UNITED STATES OF AMERICA
NUCLEAR REGULATORY COMMISSION

BEFORE THE FACT-FINDING TASK FORCE

RE: Davis-Besse Event of June 9, 1985

Location: Bethesda, Maryland
Date: Thursday, June 27, 1985

Figure 1

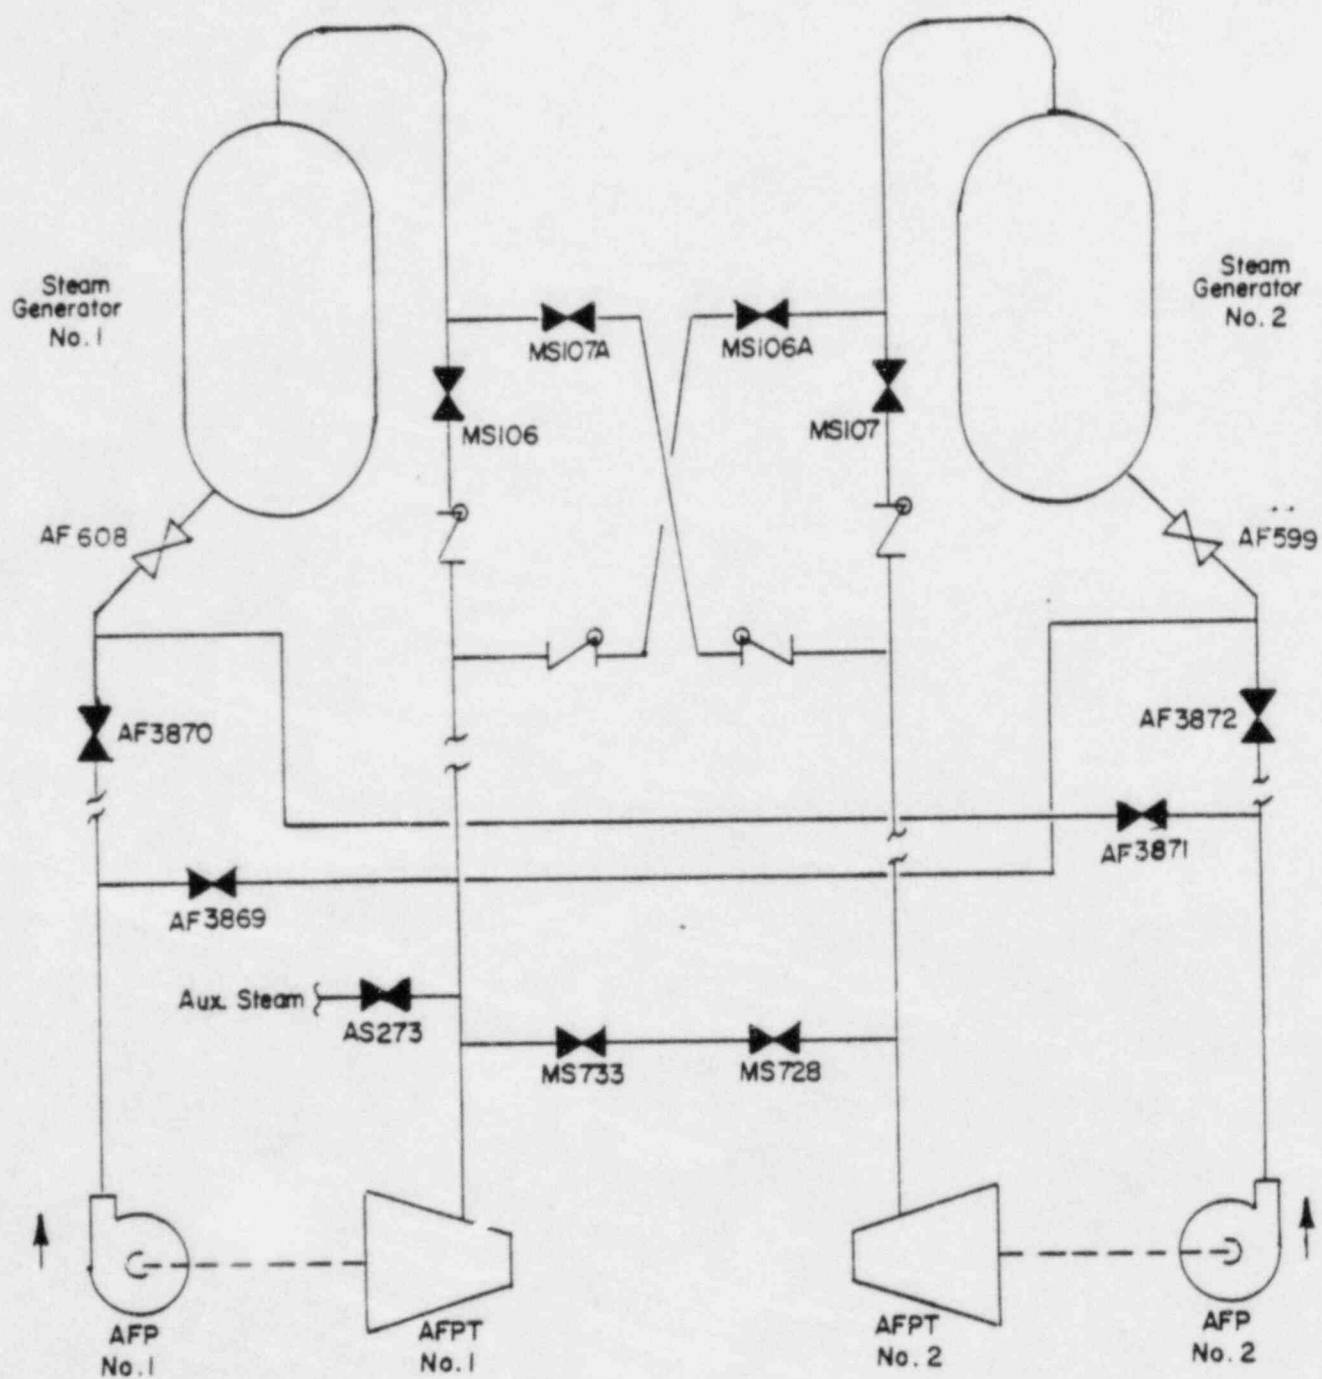
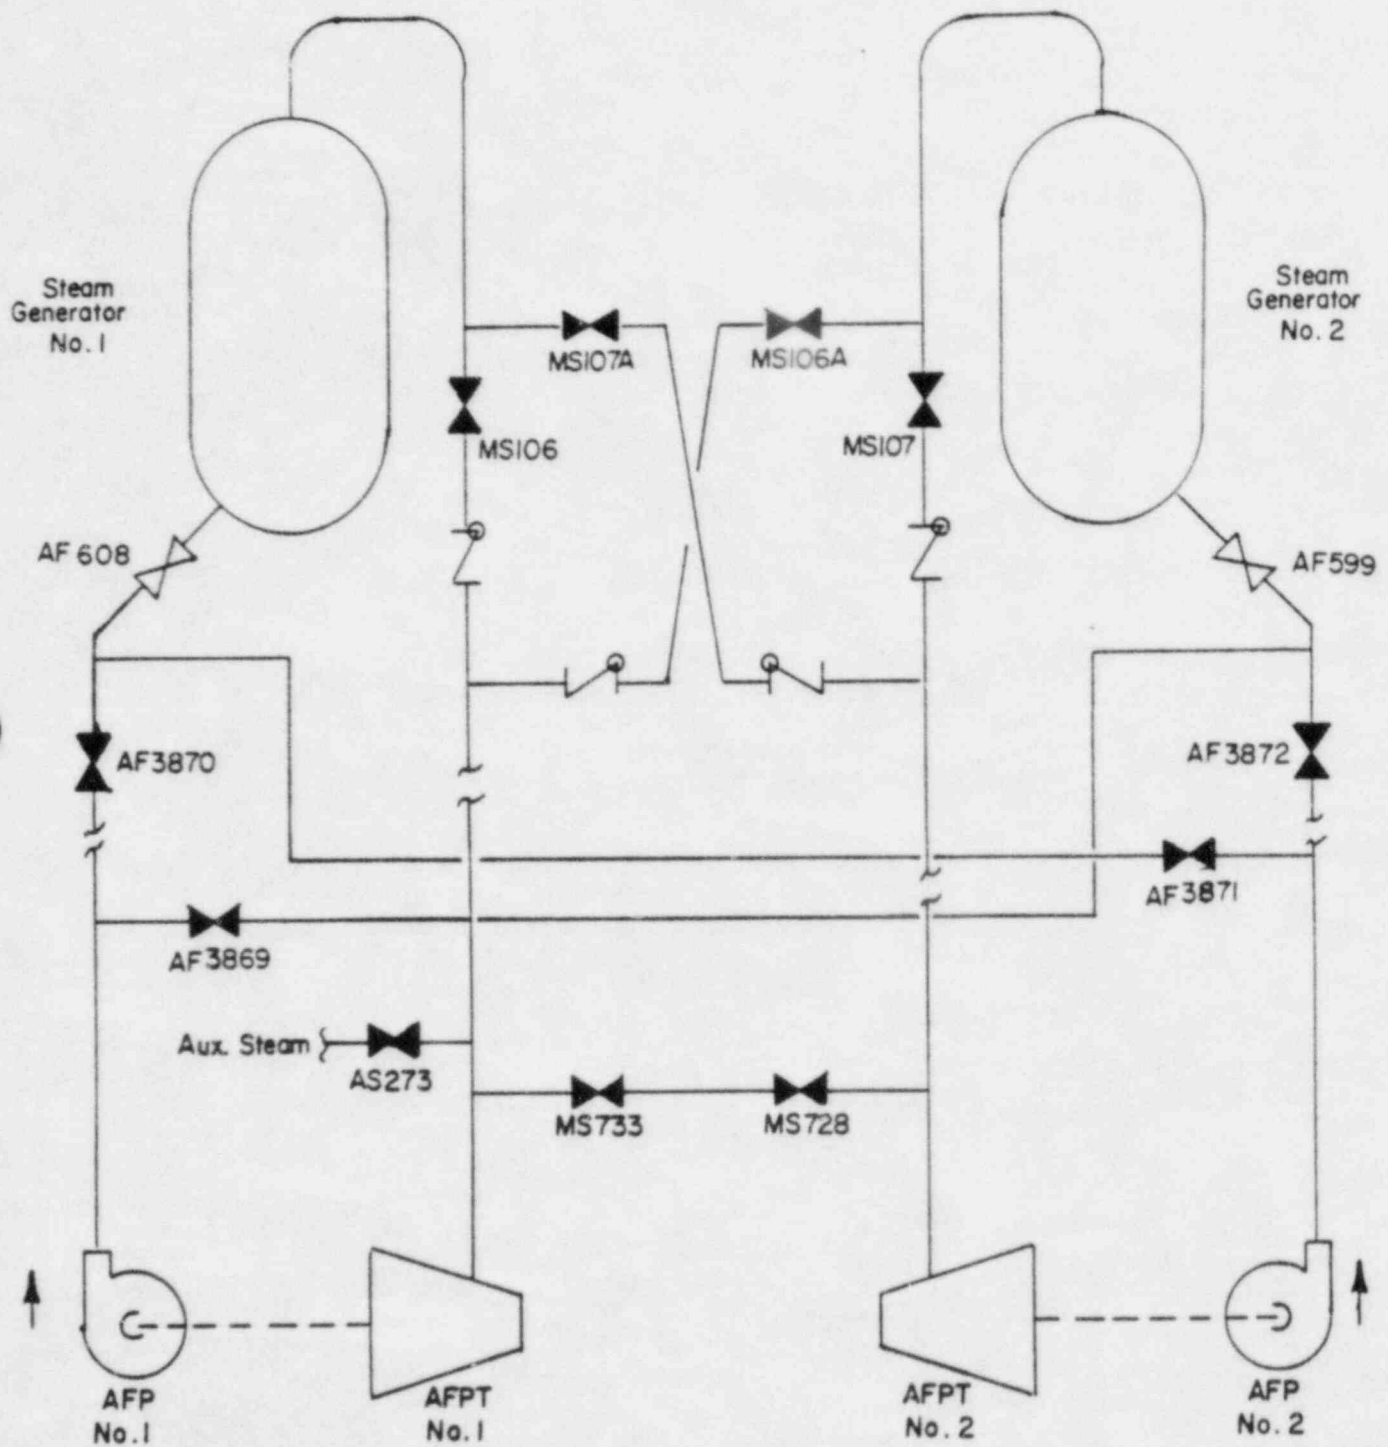
12 MR. BEARD: Well, I guess page 2 is where you
13 reference Attachment 1 and Figure 1, and maybe this is the
14 time to jump over and cover that information before we get it
15 out of context.

16 As I remember, as I turn the pages here, Attachment
17 1 is really two pages, a one-page description and narrative
18 and one page of figures, which, by the way, I think is a
19 pretty clear figure.
